**Manhattan Village Shopping
Center Enhancement Project
Sepulveda Boulevard between
Rosecrans and Marine**

**City Council
November 12, 2013**

COMPLETED NORTHWEST COMPONENT SUMMARY - RETAIL ONLY OPTION

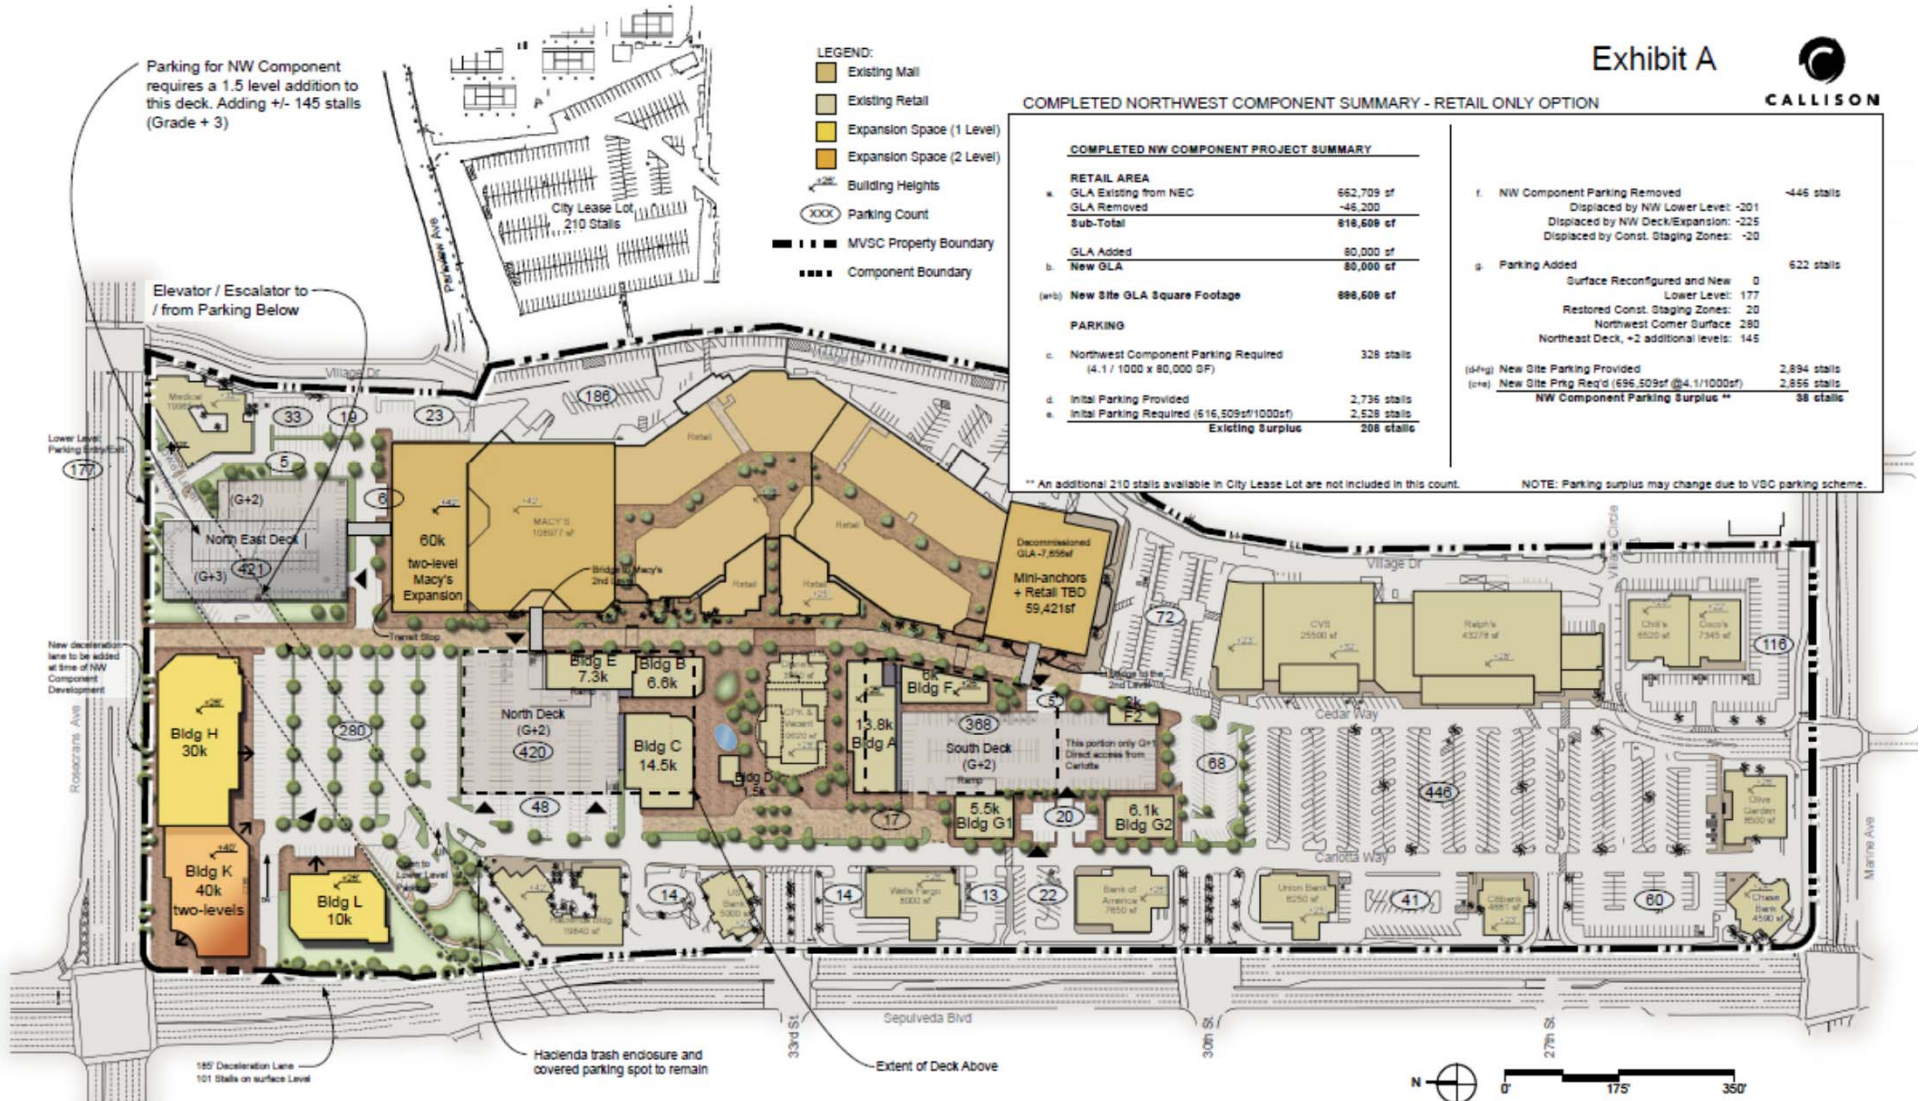
- **Phase I North Parking Structure-** moved north; Plaza
- **Cedar Way/Rosecrans connection-** Phase II not Phase III
- **Phase III** – L-shaped buildings at corner
- **Medical/Dental offices** – No caps at 3500 Sepulveda
- **Banks** -limited to 2000 s.f. and no stand-alone uses
- **Financial security** - for public improvements prior to Phase I
- **Oak Ave Traffic Study** – funding for study
